Z-75
(2014)

PROJECT TITLE
REZONING SITE PLAN

PETITION NO: Z-75

ZONING COMMENTS:

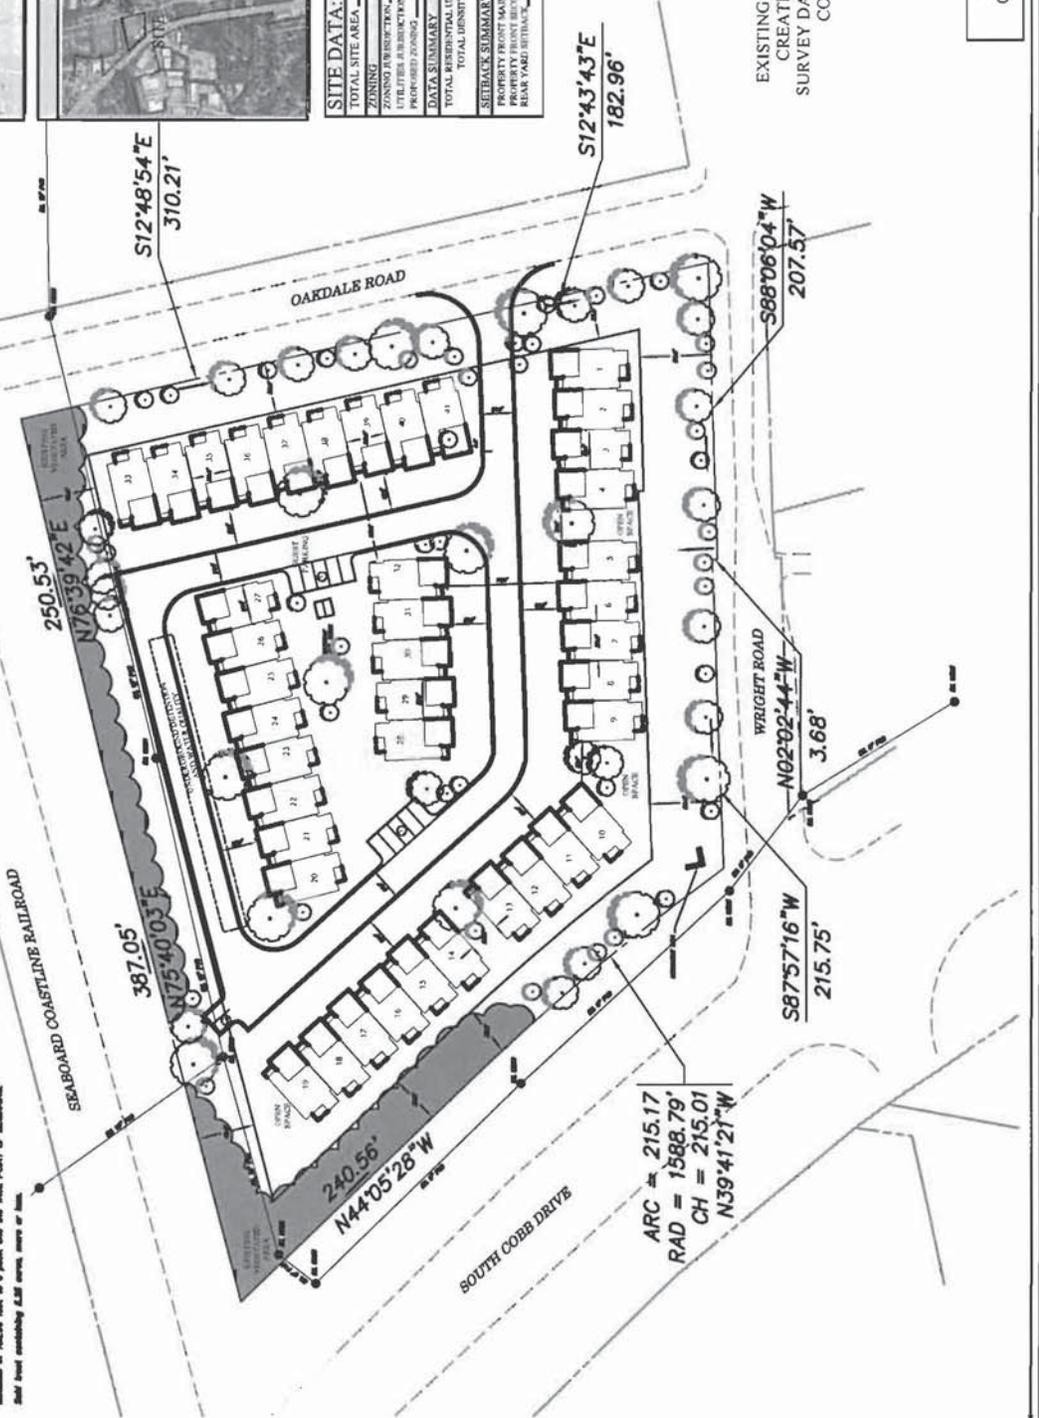
When projects contemplate less than 20 foot separation between units, guest parking shall be provided or the streets shall be labeled as a fire lane.

- No Stormwater controls shown _____
- Copy of survey is not current – Additional comments may be forthcoming when current site conditions are exposed.
- No site improvements showing on exhibit.

1. This parcel is bounded by Oakdale Road to the east, Wright Road to the south, South Cobb Drive to the west and the Railroad to the north. The entire site drains to the east to an existing culvert under Oakdale Road. This culvert has been extended partially through the site. This conveyance drains approximately 75 acres from the drainage basin to the north of the railroad. To accommodate the proposed layout, the existing pipe system will need to be relocated and sized to accommodate the onsite as well as offsite 100-year design flow. This may require a stream buffer variance, which will be determined at Plan Review.
2. The proposed site plan shows the underground detention system located beneath the street. The applicant has agreed to Stormwater Management’s recommendation to relocate this facility to the open space area to significantly reduce future maintenance costs.

Recommend applicant consider entering into a development agreement pursuant to O.C.G.A. 36-71-13 for dedication of the following system improvements to mitigate traffic concerns: a) donation of right-of-way on the north side of Wright Road, a minimum of 25' from the roadway centerline.

Recommend curb and gutter along both sides and sidewalk along one side of proposed development roadway.
